PREVOST

**SAFETY
RECALL**

Sr12-29

DATE : SEPTEMBER 2012	SECTION : 23-ACCESSORIES
SUBJECT : AUTOMATIC FIRE DETECTION AND SUPPRESSION SYSTEM (AFSS) – PROTECTION OF LINEAR THERMAL DETECTOR (LTD)

IR OPTICAL
FIRE DETECTOR
LOCATION

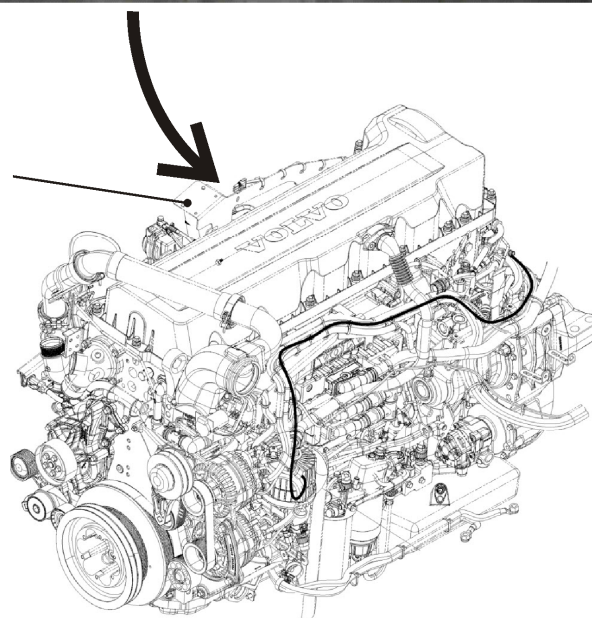
PROTECT LINEAR THERMAL DETECTOR SHEATH FROM RUBBING AT THIS LOCATION. CUT NYLON TIE AND ADD INSULATING FABRIC ADHESIVE TAPE. FIX WIRE WITH A NEW NYLON TIE.

1. There is only one location where the protective fabric tape might be too short or improperly located. Check the engine turbocompressor side near the optical infrared (IR) fire detector (see image above).

2. Cut and remove the existing nylon tie. Add enough fabric tape to protect LTD (red cable) from rubbing against the nylon tie. Fix LTD cable at the same location using included nylon tie.
